RBWM Comments on the Regulation 14 Consultation draft of the Maidenhead Neighbourhood Plan

December 2024

Policy HO-2 Market Housing Mix

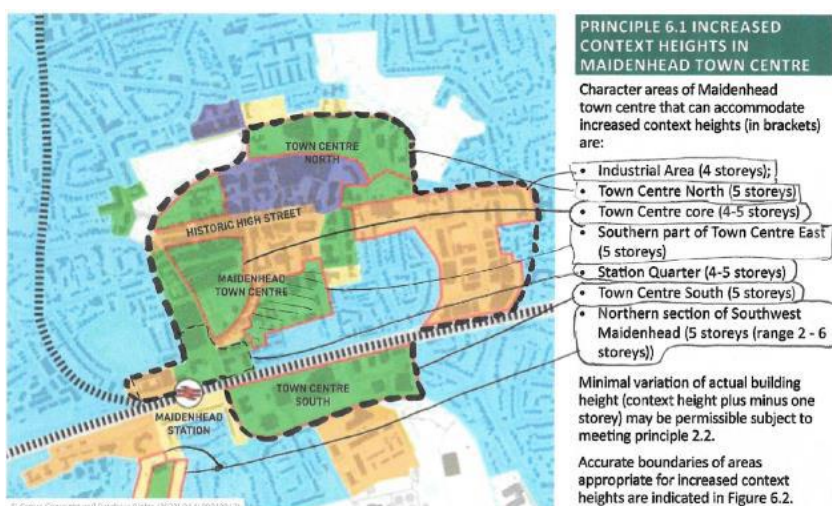
The aspiration of securing more family housing outside of the town centre is welcomed. There will be site specific circumstances where this cannot always be achieved, and this should be recognised in the policy, as the BLP supporting text also recognises that there will be local circumstances that will need to be taken into account.

In addition, the BLP allocated sites outside of the town centre provide an opportunity to deliver more family housing. Site proformas in the BLP set out site specific requirements for the allocated sites. In relation to the largest of these, site AL13, this sets out detailed requirements in relation to the form of development in the two distinct neighbourhoods that will make up that development area. The South West Maidenhead SPD develops this thinking further in terms of what it means for dwelling mix across the site. In this instance, achieving 80% 3 and 4 bed units may prove to be unrealistic and not consistent with the BLP policy proforma requirements across the allocation as a whole.

- ***Subject to local circumstances and requirements in the Borough Local Plan site proformas (Appendix C of the BLP), outside Maidenhead Town centre the market housing element of development proposals are expected to provide 20% flats (1 and 2 bed) with 80% maisonettes and houses (3 bed and above).*** **MNF 1.5**
